Reply to NOV Report No.05200046/2016-202

## **Reply to a Notice of Violation (NOV): NRC Inspection Report No.05200046/2016-202**

DCD markups

APR1400 DCD TIER 2

Figure 3.8A-40 Reinforcement Arrangement of the AB MSIV House Wall (Section 1)

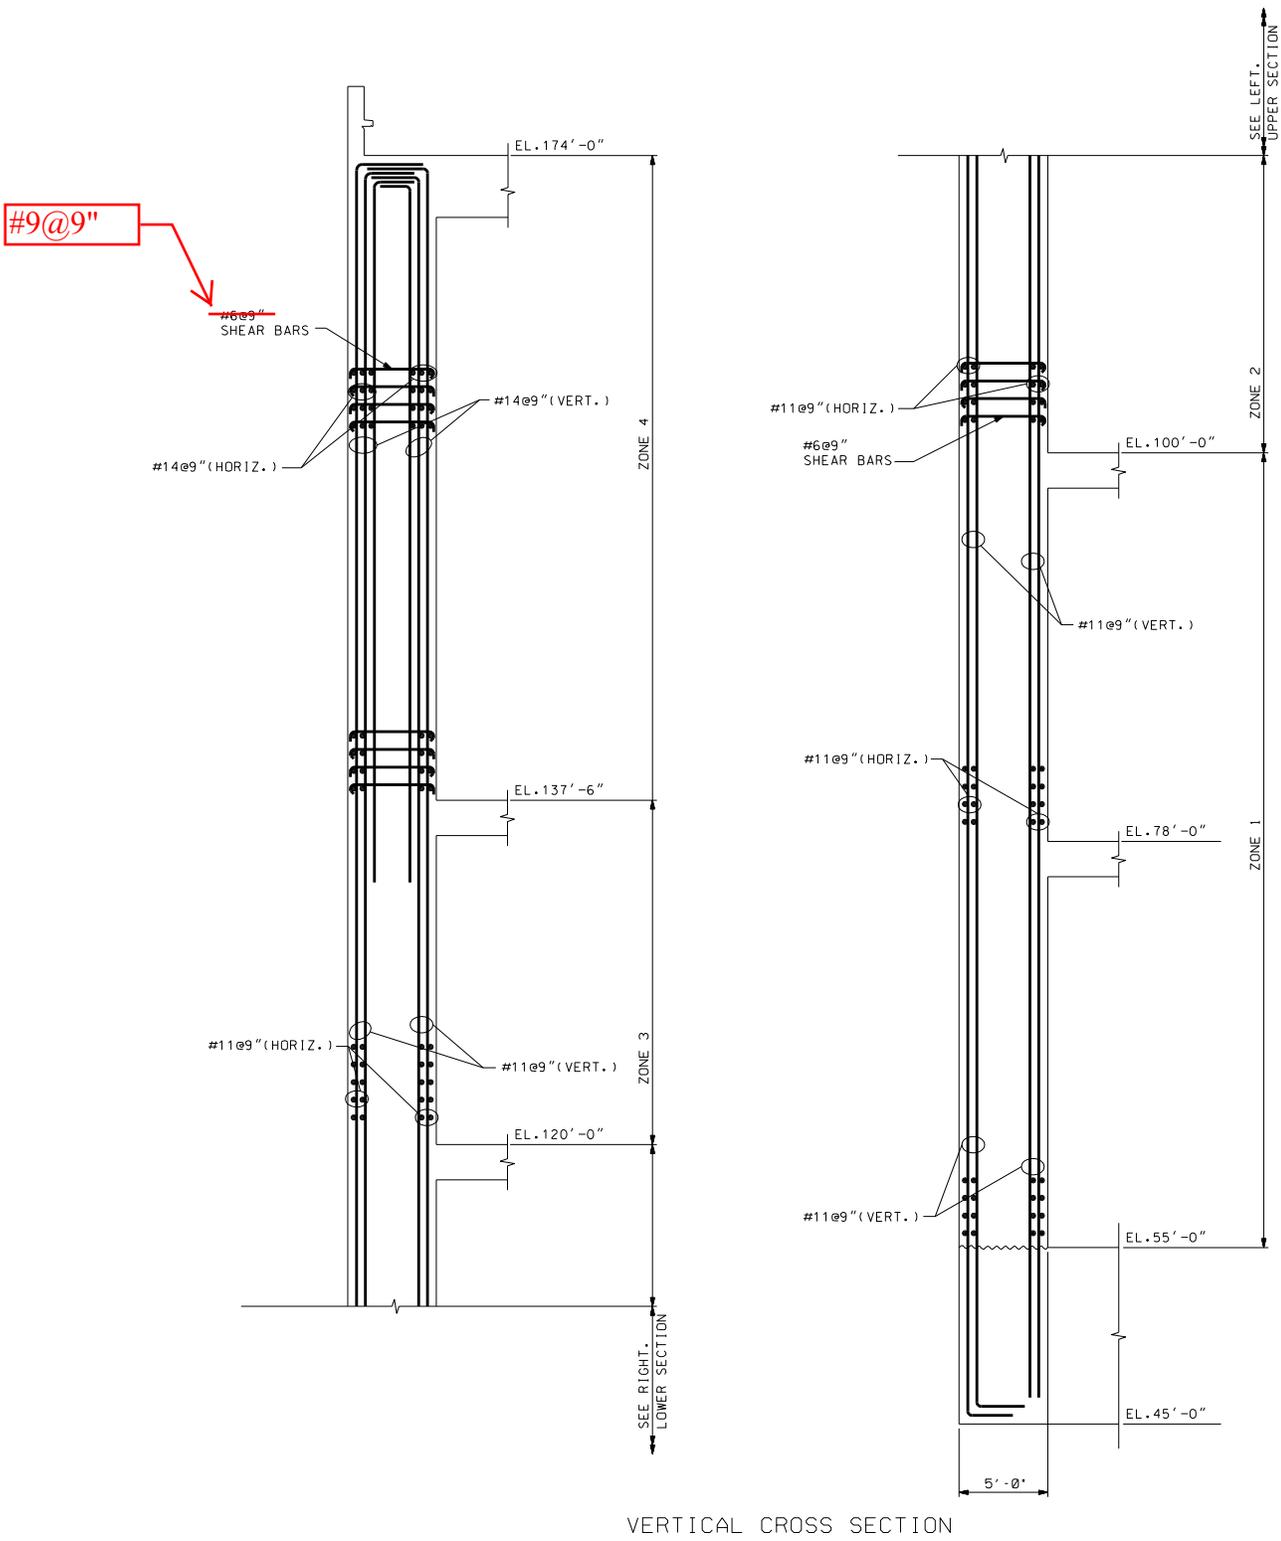
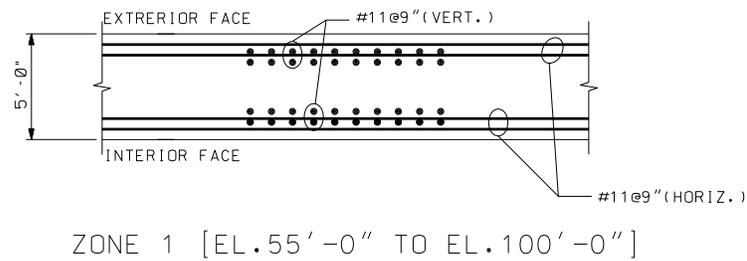
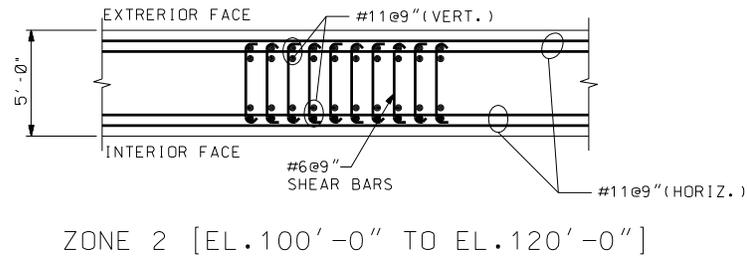
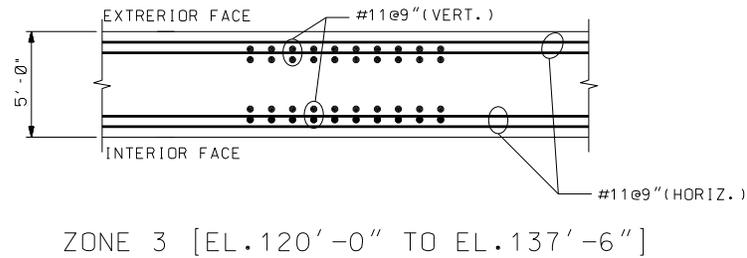
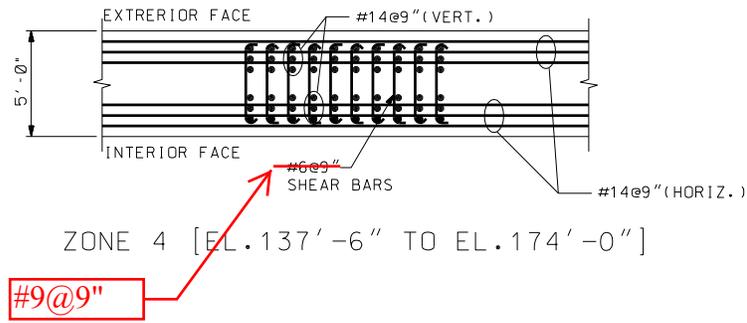
- 1) The ultimate heat sink (UHS) is added to Section 19.5.4.4 in DCD as a key design feature.
- 2) The cabling routing for the safety-related instrumentation and control in the A and B equipment rooms is added to Section 19.5.4.4 in DCD as a key design feature.
- 3) The window size of viewing areas in the A and B diesel generator control rooms is added to Section 19.5.4.2 in DCD as a key design feature.
- 4) The wall and the size of rebar used in the exterior walls of the main steam

valve rooms are revised and added to Section 3.8A (Table 3.8A-29, Figure 3.8A-40, 3.8A-41) and 19.5.4.2 as a key design feature.

Figure 19.5-11 Polar Crane Bracket

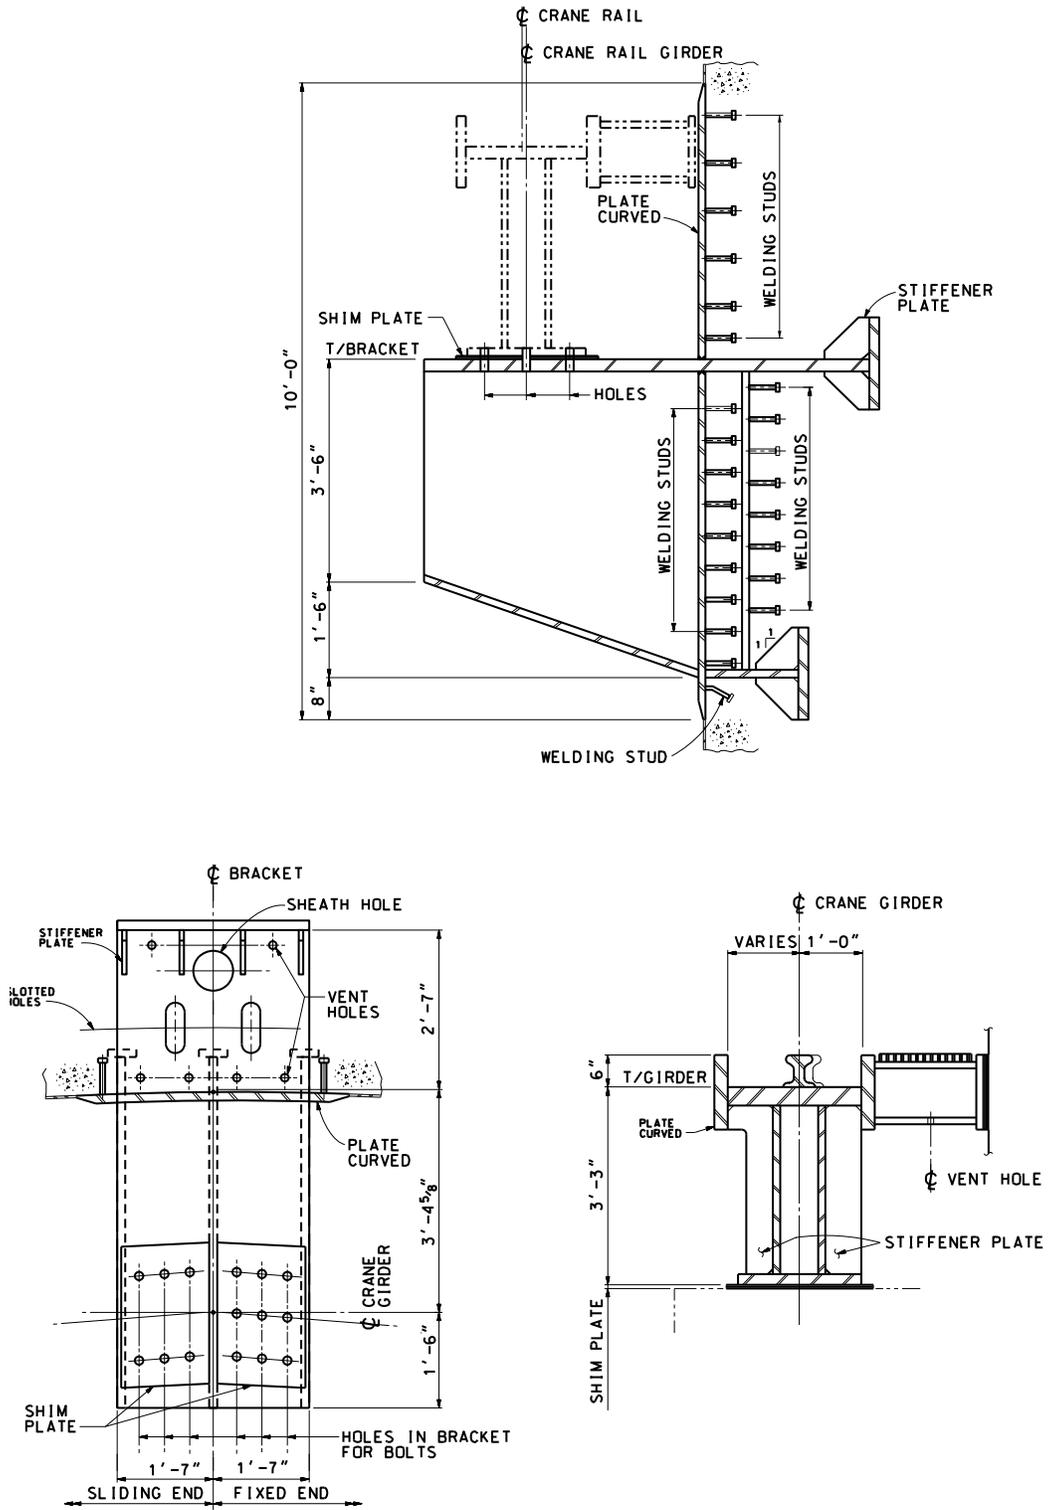
The polar crane bracket and rail girder shown in Figure 19.5-11, are key design features to protect the safety system located inside containment from the drop of polar crane due to the impact of a large commercial aircraft. The polar crane brackets and girders shall be ASTM A588 Grade A or B and the bolts for the connection between polar crane bracket and rail girder shall be minimum 1.5" diameter ASTM A490X. The design of polar crane bracket and rail girder is performed to maintain adequate design margins. The summary of design results and material properties are shown in Table 19.5-1.

Add figures 19.5-11 through 19.5-16
